# UNITED STATES PATENT AND TRADEMARK OFFICE

APPLICATION NO.	FILING DATE	FIRST NAMED INVENTOR	ATTORNEY DOCKET NO.	CONFIRMATION NO.
09/839,001	04/20/2001	Harald Apfelthaler	KWO-17702/01	2739

**Office Action Summary**

## **DETAILED ACTION**

EXHIBIT

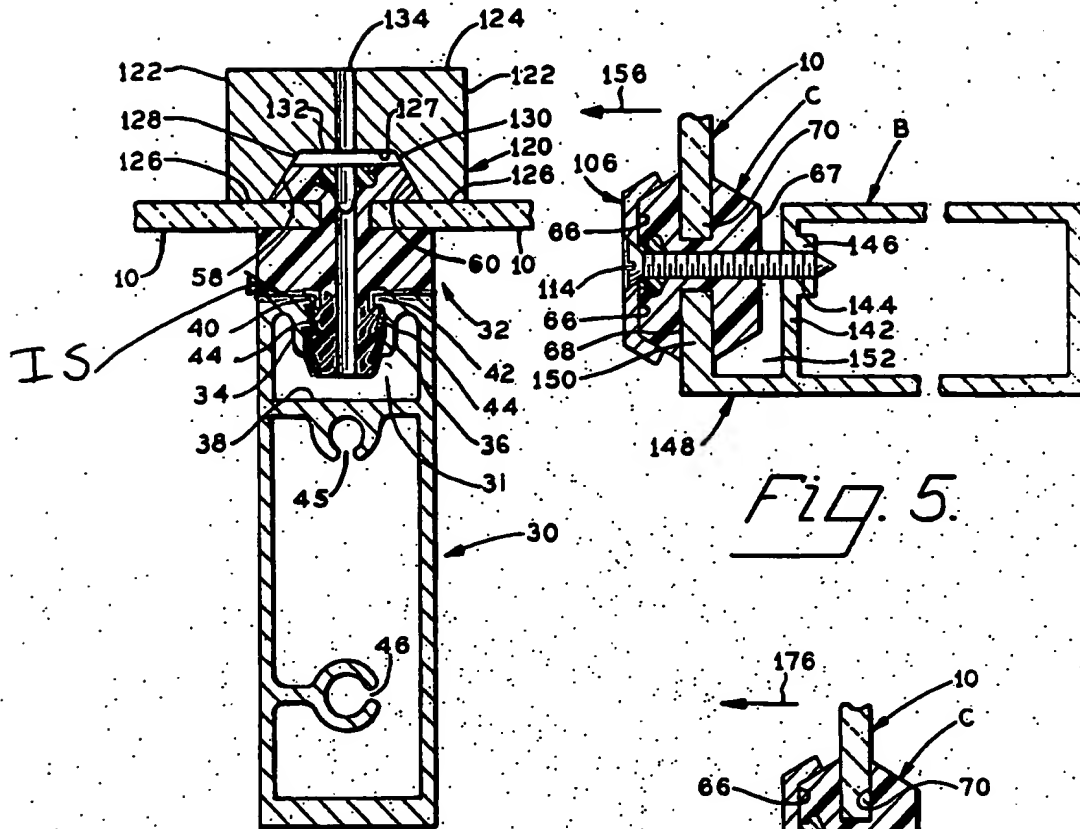
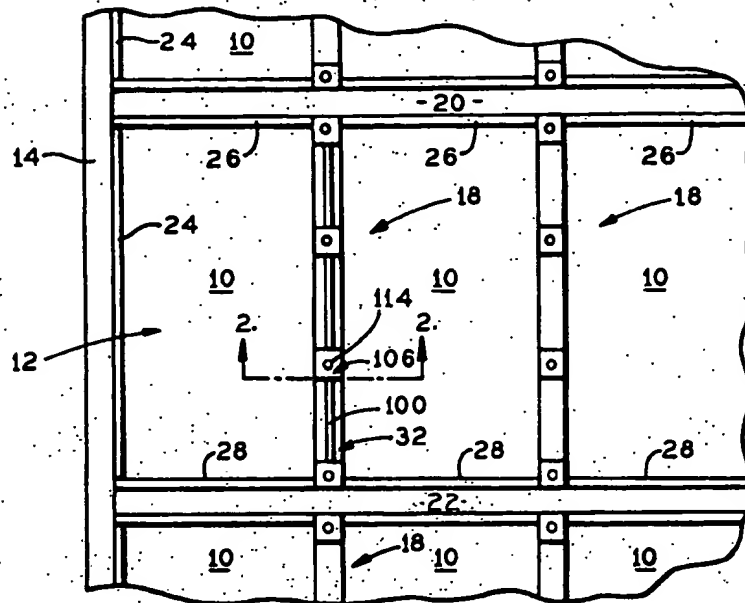
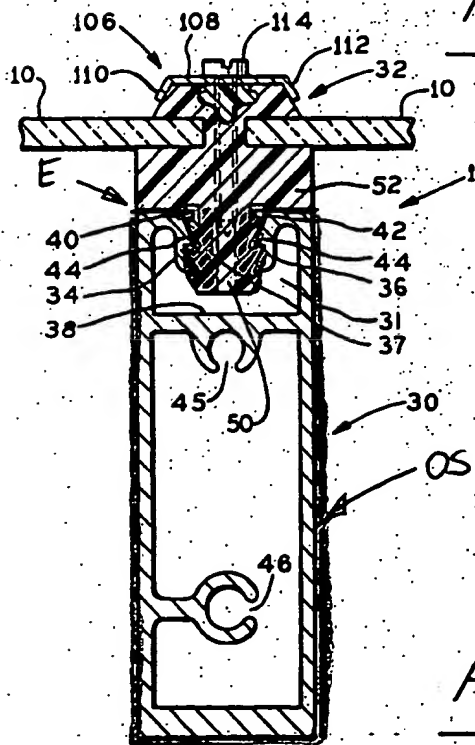
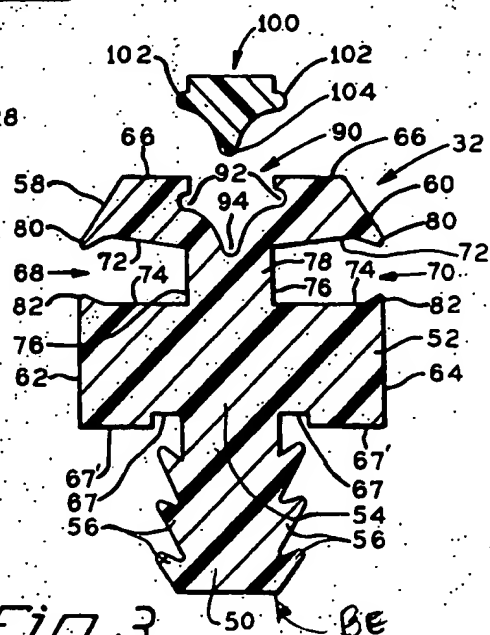
Claims 3,4,6 and 20 are rejected under 35 U.S.C. 102(b) as being anticipated by US Patent #3,766,698 to DALLEN. DALLEN discloses the use of a plug (32) having upper end (as at 66) and a bottom end (BE), see the marked attachment, in combination with a muntin (30) having an outer surface (OS), an end (E), inner walls (IS) having a planar surface (40,42) that define a hollow space (31), see the marked attachment, and flanges (67'), a plurality of spring elements (56) such that the spring elements (56) are operable to engage the planar surface (40,42), see figures 2 and 4, and the plug (32) includes a body (50,52,54,78) having a longitudinal slot (134), column 6, line 33-39 and column 7, line 20-30, wherein the body (50,52,54,78) fits into the hollow space (31) of the muntin (30) wherein the plug body (50,52,54,78), upon insertion of a screw (114) into the longitudinal slot (134), is operable by "forcing the body (50,52,54,78)", column 6, lines 33-39, into the muntin (30). Upon insertion of the screw (114), the body (50,52,54,78) is also forced apart from one another, and into engagement with portions (34,36) of the muntin (30). In regards to the longitudinal slot (134), due to the fact that the longitudinal slot (134) is drilled through the gasket (32)

and plug (100), and the upper end of the gasket (32) already has a different width at the top as at (90), the slot (134) formed therein, once drilled therethrough, would inherently open up into this different width area (90) thereby creating a longitudinal slot (134) having a different width (90) at the upper end (as at 66) than that at the bottom end (BE). In reference to claims 3 and 4, the slot (134) is coaxially aligned with the plug body (50,52,54,78) and completely penetrates the plug body (50,52,54,78), see Figure 4. regarding claim 6, again, due to the fact that the longitudinal slot (134) is drilled through the gasket (32) and plug (100), and the upper end of the gasket (32) already has a greater width at the top as at (90), the slot (134) formed therein, once drilled therethrough, would inherently open up into this greater width area (90) thereby creating a longitudinal slot (134) having a greater width (90) at the upper end (as at 66) than that at the bottom end (BE).

Claims 8-11 are rejected under 35 U.S.C. 103(a) as being unpatentable over US Patent #3,766,698 to DALLEN in view of US Patent #5,205,688 to SUNDSTROM. DALLEN discloses the basic claimed muntin and terminal plug combination except for the use of the longitudinal slot having a slotted wall or teeth. SUNDSTROM teaches that it is known in the art to provide a slot (2) with teeth (5). Hence, it would have been obvious to one having ordinary skill in the art at the time the invention was made to provide the longitudinal slot of DALLEN with the teeth of SUNDSTROM, in order to increase the tension between the plug body and the screw thereby increasing the friction therebetween to resist separation thereof and securely fasten the two members together. Regarding to claim 9, because the slot (134) has a widened area (as at 90 in figure 3) at the upper end (as at 66), the opposing walls that becomes smaller (see figure 4) towards the bottom end (BE). In reference to claim 10, obviously, it would have been obvious to one having ordinary skill in the art at the time the invention was made to form the teeth (5) of SUNDSTROM in the slot (134) of DALLEN such that when the screw (114) is passed through the slot (134) a tip thereof (possibly the ends of the threads) abuts the teeth (5) where provided with the commonly known slots or teeth to enforce "widening" of the slot (134). Regarding claim 11, the longitudinal slot (134) is drilled through the gasket (32) and plug (100), and the upper end of the gasket (32) already has a greater width at the top as at (90), the slot (134) formed therein, once

drilled therethrough, would inherently open up into this greater width area (90) thereby creating a longitudinal slot (134) having a greater width (90) at the upper end (as at 66) than that at the bottom end (BE).
